ITEM 2. DEVELOPMENT APPLICATION: HAROLD PARK - 10 MAXWELL ROAD - 72 AND 74 ROSS STREET - 1A AND 1B THE CRESCENT - FOREST LODGE - STAGE 2 - PRECINCT 1

FILE NO: D/2011/1311

SUMMARY

Summary: Stage 2 application for Precinct 1 at Harold Park comprising construction of 4 residential apartment buildings (5-8 storeys) containing a total of 298 apartments, basement parking for 252 cars and associated landscaping.

Figure 11: 3D massing showing the portion of Building 1C. The hatched area shows the portion of the building which exceeds the height control by 1 storey.

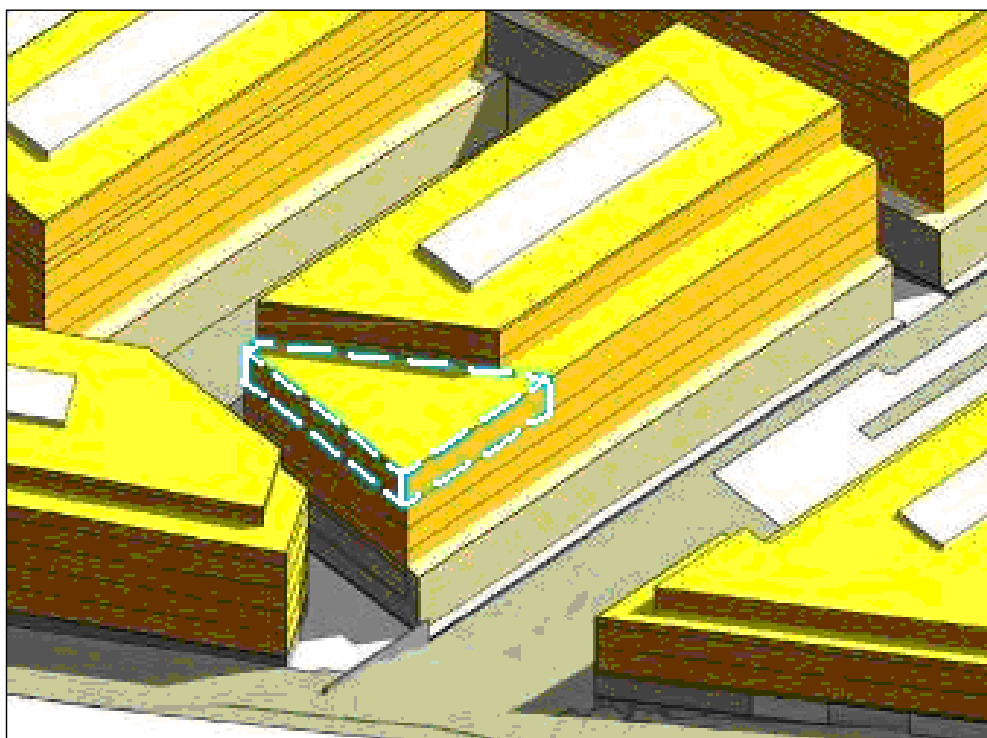
52. Building 1C straddles two different height controls – most of the building is located in an 8 storey zone but the northwest corner is in a 5 storey zone.

53. Building 1C is proposed to be 8 storeys with a 6 storey street frontage height. This means that the proposal exceeds the 5 storey height control by 1 storey in one portion of the site, as shown at Figure 11 below:

54. The non-compliance is considered to be an acceptable outcome as the application of the height in storeys control will result in a poorly proportioned elevation; the base to top ratio being approximately 50/50.

Figure 12: Section through Precinct 1, looking north.

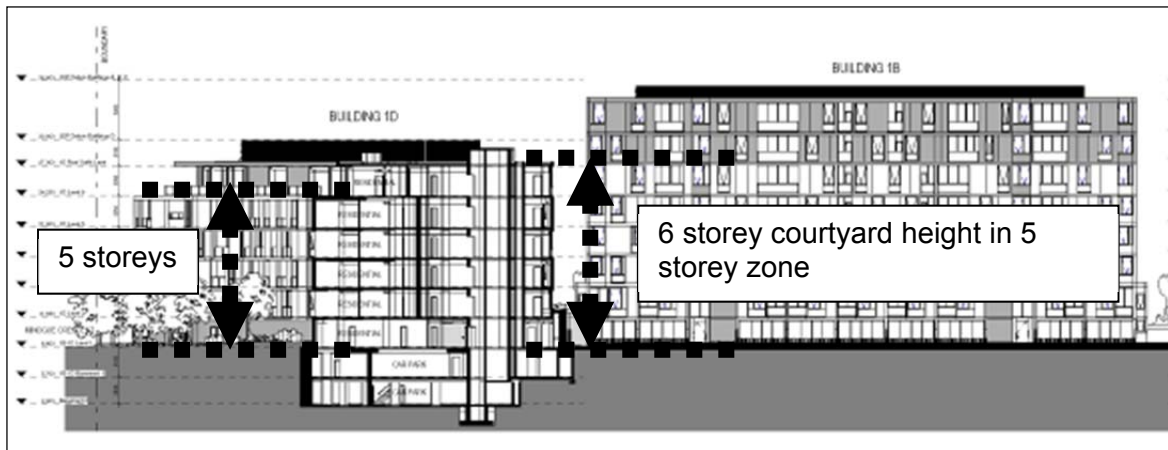
57. Building 1D straddles two height controls - 5 and 6 storeys to Minogue Crescent. Owing to the fall of the land, an additional 6th storey has been gained in the 5 storey zone to the courtyard, as shown at Figure 12 below:

58. Council's original Stage 1 DA assessment concluded that subject to demonstration of adequate amenity and solar access to future dwellings and compliance with FSR and other planning controls, an additional storey to the courtyard could be considered with a detailed Stage 2 DA.
59. In regards to amenity and solar access, the provision of an additional courtyard storey is considered positive as it provides for an increased proportion of north facing apartments. The additional storey does not result in a non-compliant FSR and is appropriately designed and positioned so as not to result in any additional environmental impact above those created by a Stage 1 DA compliant scheme.

Figure 13: Analysis of entry points and lines of defence. Existing proposed entry points shown as an arrow.

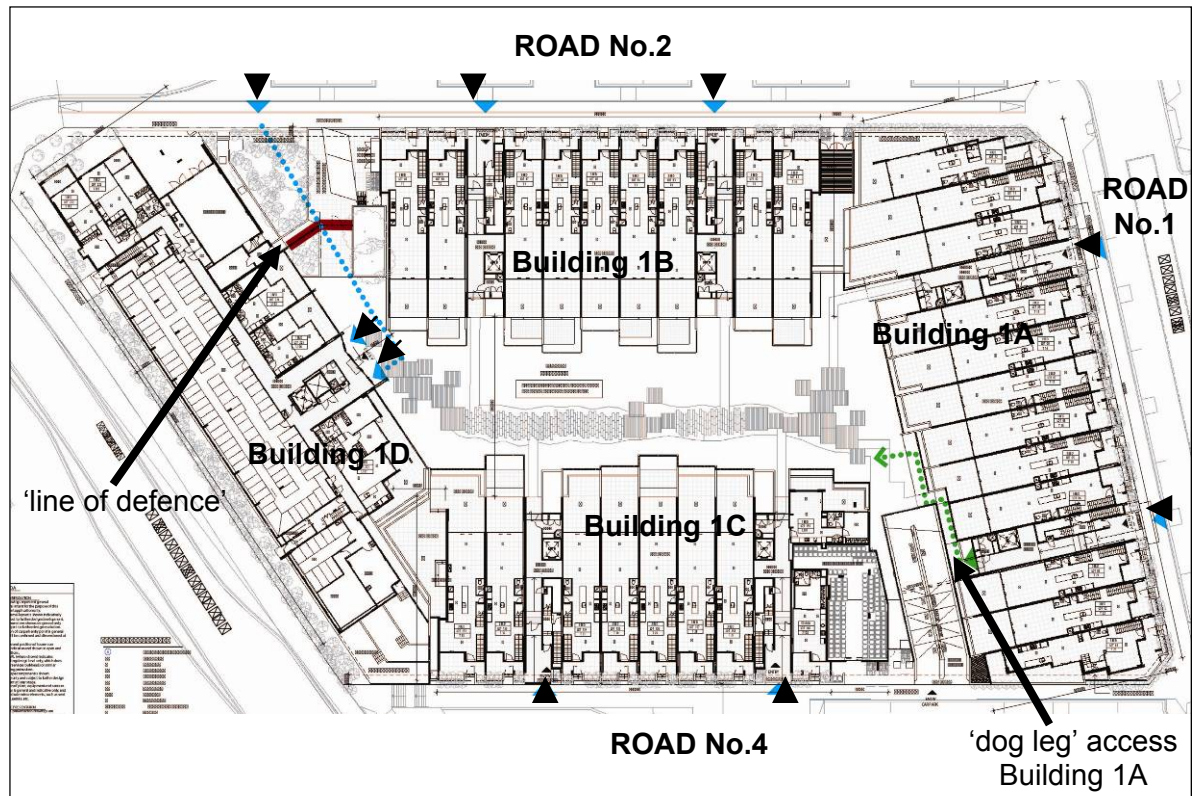
61. Building 1D has no direct street address. Visitors and residents have to cross through a 'line of defence' or gate, enter through the communal courtyard to access the entry lobbies to Building 1D.

62. The potential for a street address and entry lobby to be provided to Minogue Crescent has been investigated. To provide an entry lobby as indicated in Figure 14 below there will be a loss of approximately 7 out of 105 storage spaces. Elevational changes would also be required including ramping to accommodate a fall in the land along the Minogue Street frontage. The loss of landscaping involved in accommodating the required ramping is considered to outway the benefit of providing the separate secondary entrance in this instance.

Figure 15: Photomontage – Entry Plaza

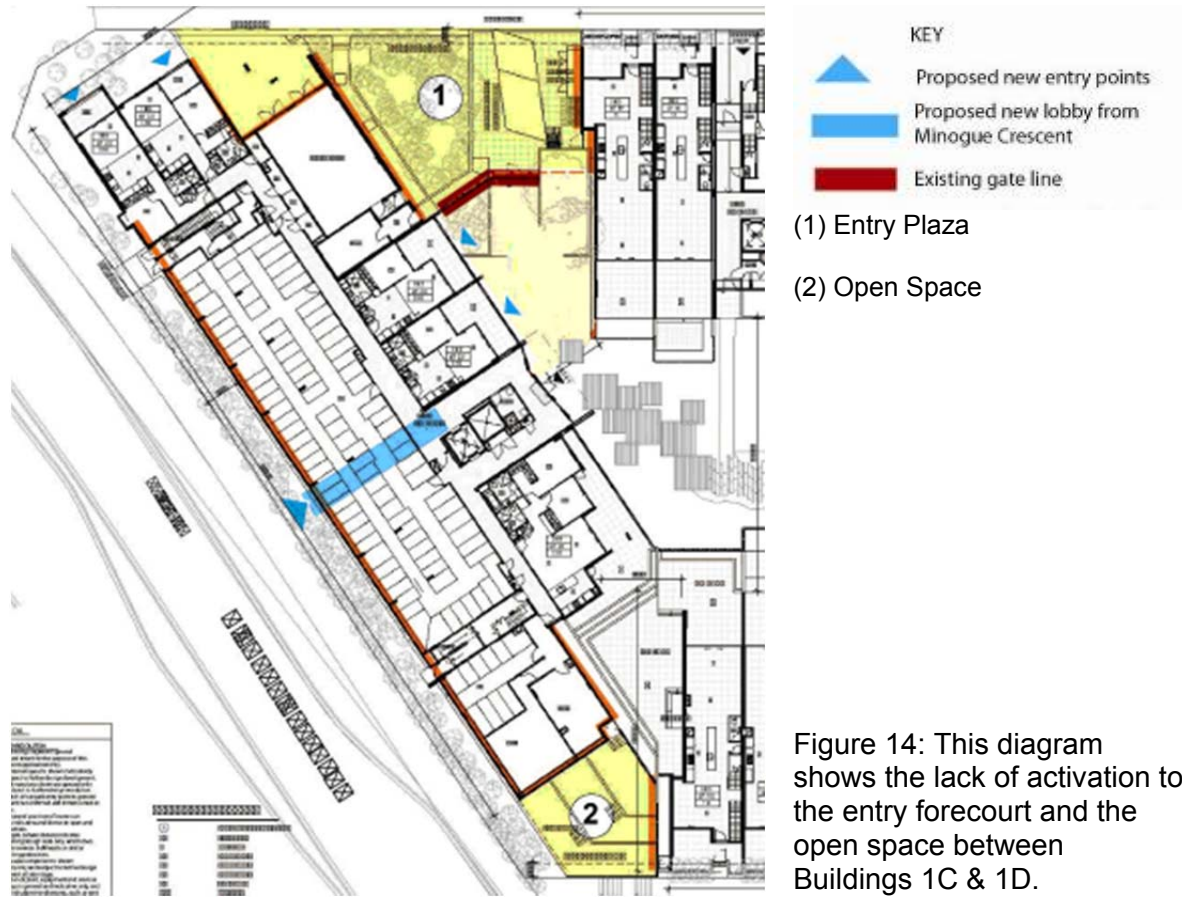
63. The Entry Plaza [shown as (1) in Figure 14 below] is poorly designed with a lack of identity and activation resulting in a poor outcome for this space. The entry canopy/letter boxes will create some CPTED issues as it creates a visual obstruction to the entry forecourt space. This area is to be redesigned and conditions are recommended.

64. The letter box location in the entry structure is not approved via a condition of consent. Conditions require the Applicant to submit a letter box strategy detailing alternate options for letter box locations, the primary objective being to secure letter box locations that assist in crime prevention and present as an integrated architectural/landscape solution. Options that could be investigated include the provision of letterboxes in individual apartment building lobbies or letter boxes built into landscape elements such as fences.

65. The open space between Buildings 1C and 1D [shown as (2) in Figure 14] also suffers from poor definition with no windows or entries to activate it. This area is to be redesigned and conditions are recommended including the consideration of public art in this location.

- (a) The area of open space between 1D and 1C and access to this space requires significant design resolution. A concept landscaped plan must be provided addressing CPTED principles, access arrangements, landscape and fencing details and the potential for the provision of public art.

Figure 16: Ground floor plan - amendments required

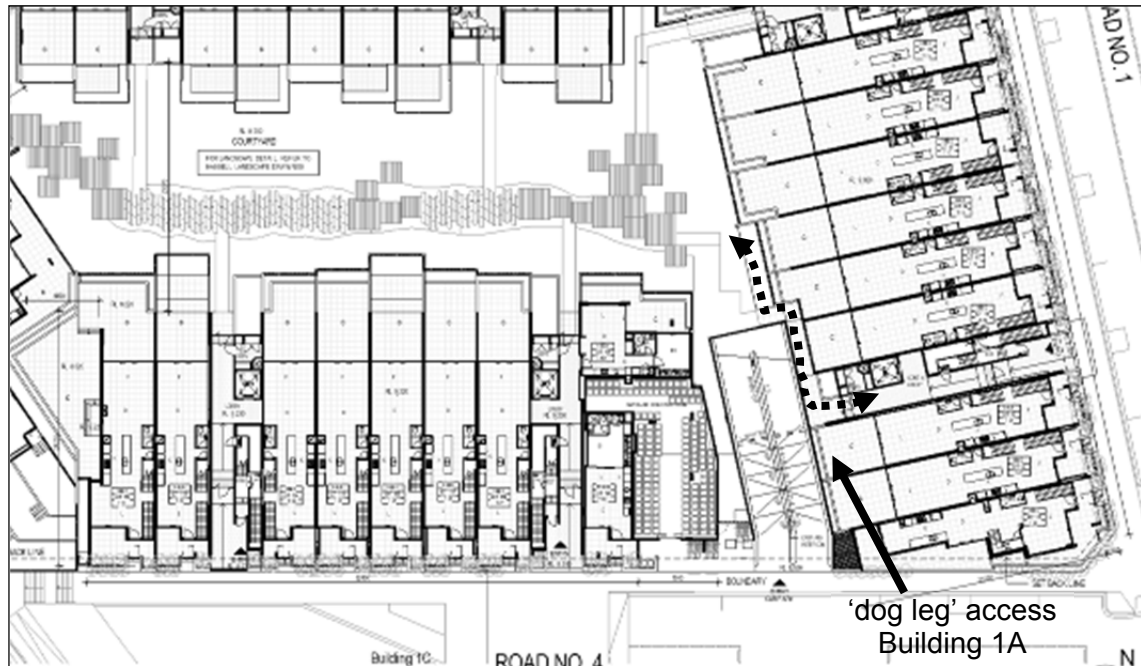
- 66. The southern entry lobby from Building 1A to the communal courtyard is indirect to the communal courtyard with 'dog leg' corners that compromise the safety and security of the residents. It is a poor spatial relationship between the entry and the communal courtyard.
- 67. A condition of consent is recommended that requires the access point to be improved by increasing the minimum width of the passage from 1.4 metres to 1.6 metres.

Figure 17: indicative landscape plan detail – typical front setback plan to primary roads

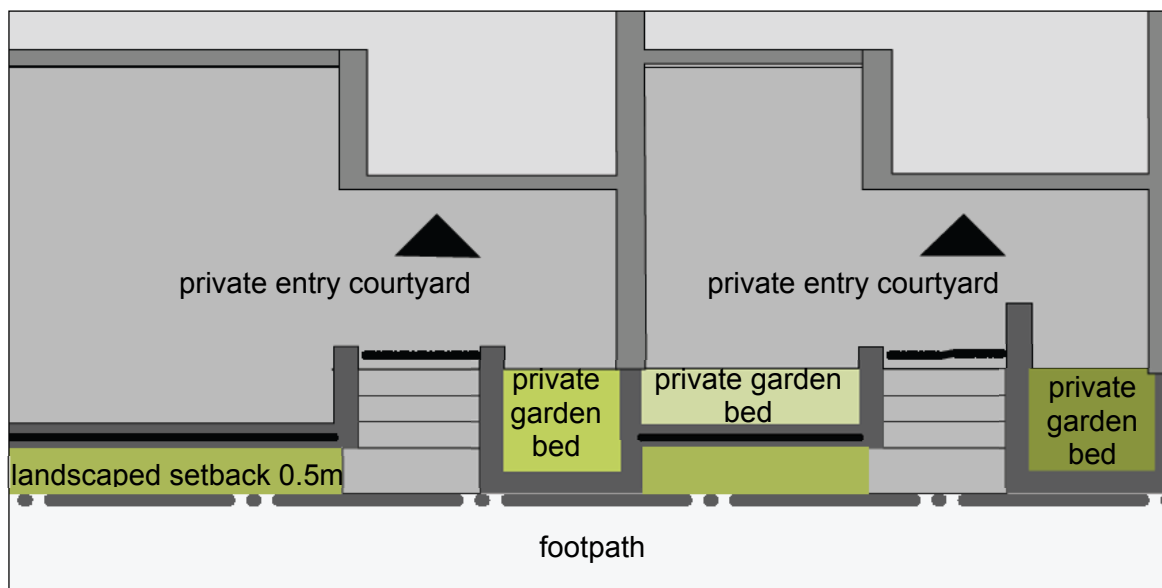
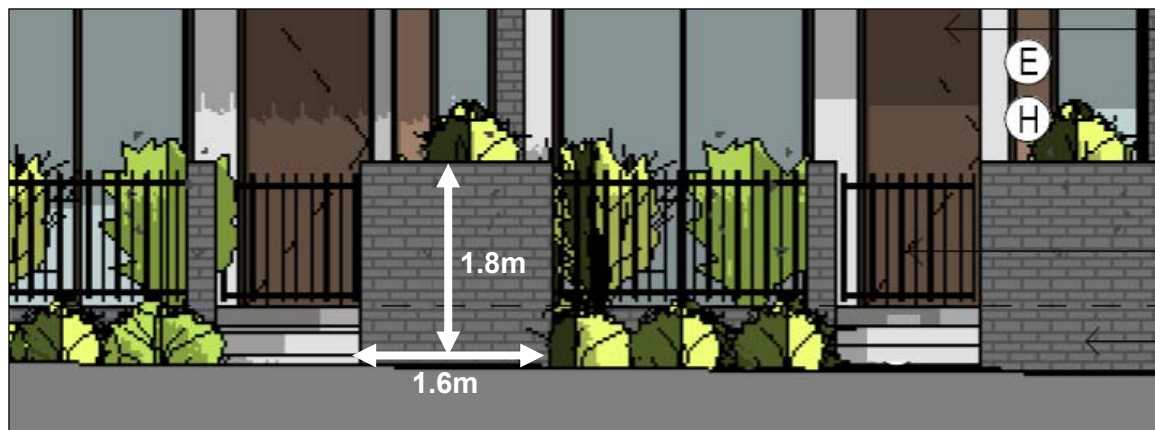
- 68. The below figures show the proposed front fence and setback arrangement for the majority of the development fronting Road No.1, No.2 and No.4.

69. The Harold Park DCP requires front fences to be:
- i) *constructed with solid masonry: 900mm above footpath level (excluding the height of any retaining wall); and*
